ADDENDUM NO. 1 - OUTLINE AND SUMMARY INFORMATION

Project Name: American Indian Hall – Outdoor Classroom PPA No.: 22-0644
Location: Montana State University - Bozeman Date: 10/08/2024
Owner: State of Montana, MSU – Bozeman
Plew Building 6th and Grant, PO Box 172760
Bozeman, Montana 59717-2760

AMERICAN INDIAN HALL – OUTDOOR CLASSROOM
MONTANA STATE UNIVERSITY
BIDDING QUESTIONS & CLARIFICATION – Oct 8, 2024

1 OVERALL FIRST FLOOR PLAN
A1.1 3/32" = 1'-0" NORTH

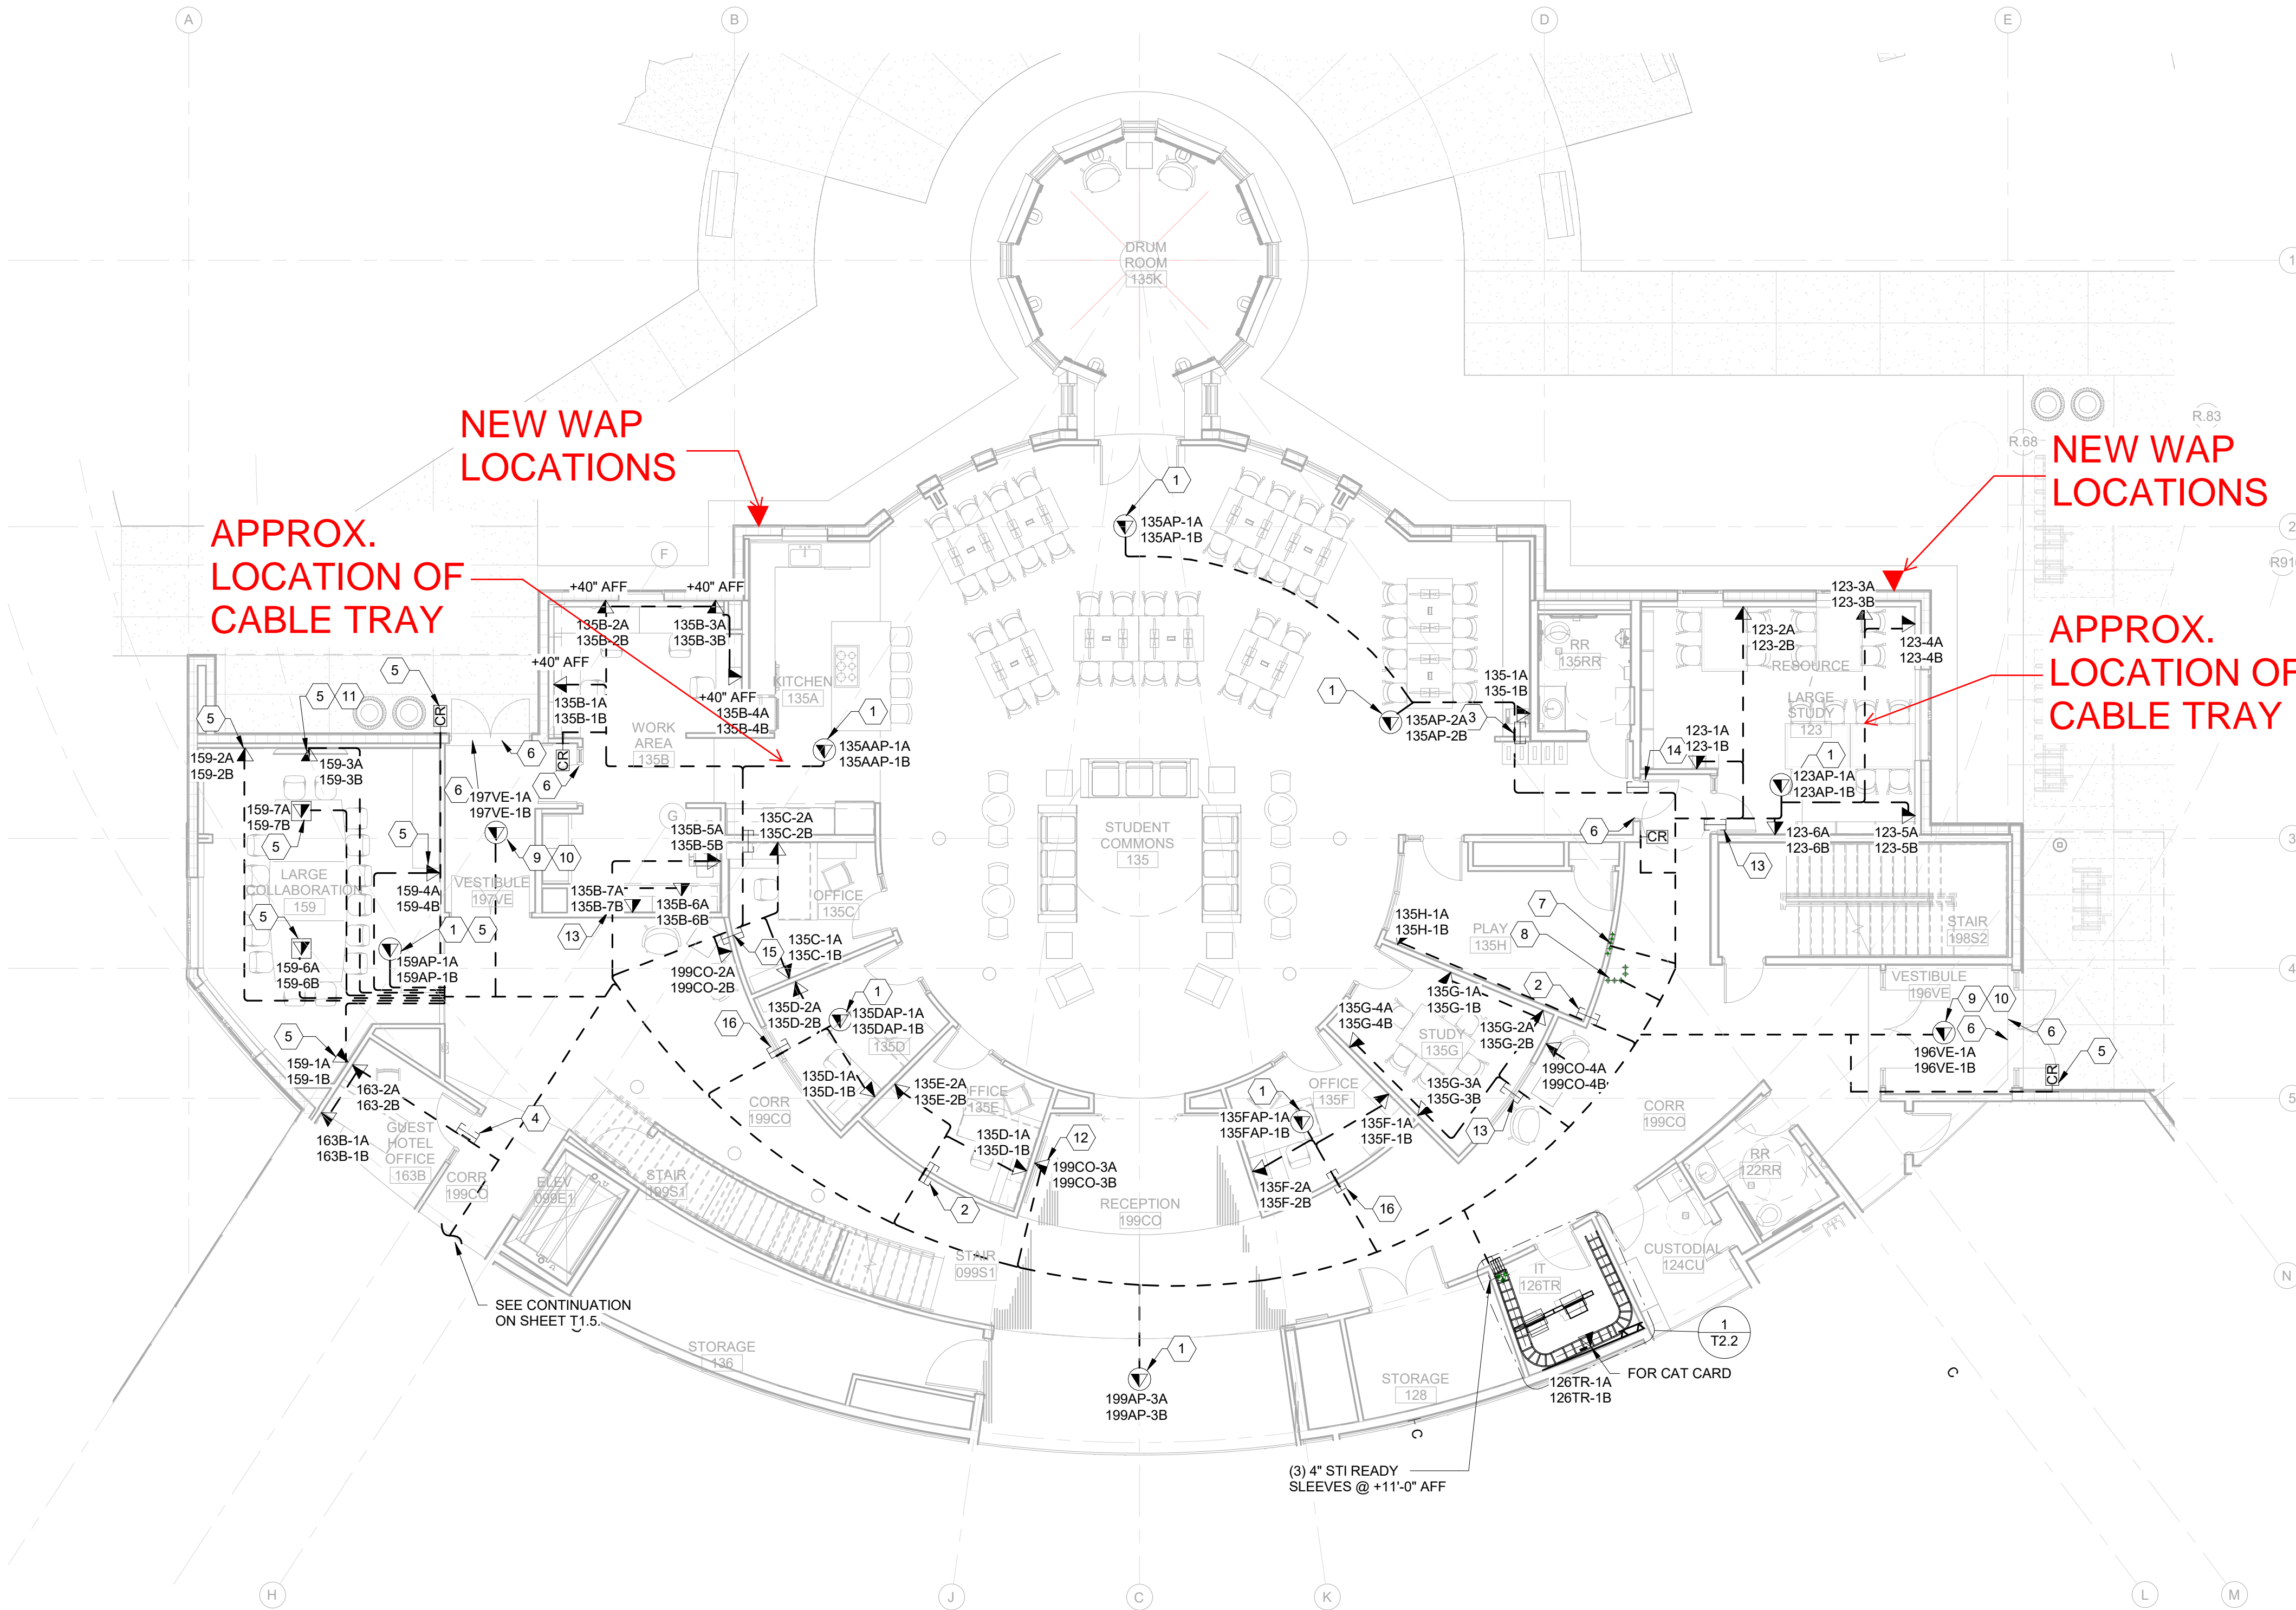
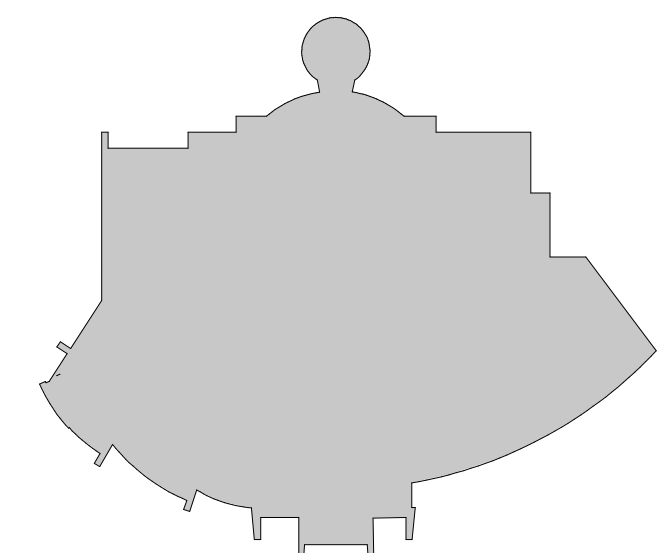
1. *Please provide information as to the location of the panel 1L3 in the existing building that we will be taking our circuits from.*
RESPONSE: Panel 1L3 is located on the first floor in the far east mechanical room. Attached is an existing floor plan showing this location.

1 FIRST FLOOR NORTH TELECOM PLAN
T1.4 1/8" = 1'-0"

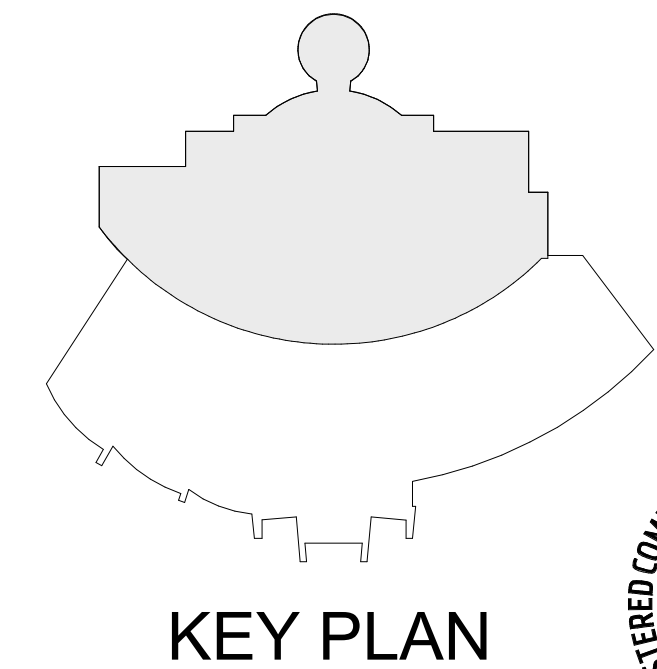
2. *Please confirm the UIT scope in regards to the WAPs. Location of nearest cable tray? What is the ceiling type in the existing building rooms where we stub in? Is it accessible?*

3. *Where will the data need to be routed too?*
RESPONSE: Data cabling for the wireless access point to be provided and pulled by MSU UIT. Conduit and j-hooks will need to be provided by the EC from the device locations as shown on the electrical plans to the nearest cable tray. Attached is an existing drawing of the approximate cable tray locations.

RESPONSE: Scope is outlined on E1.1, note 7. Contractor is to provide rough-in and conduit to get through the exterior wall and into the ceiling space. Contractor is also to provide conduit or J-hooks to get to the nearest cable tray. Attached is an existing drawing of the approximate cable tray locations. Owner will provide and install the WAP unit and cabling. The space nearest the east WAP has an APC ceiling. The space nearest the West WAP has an APC ceiling with gyp board soffit around the perimeter.
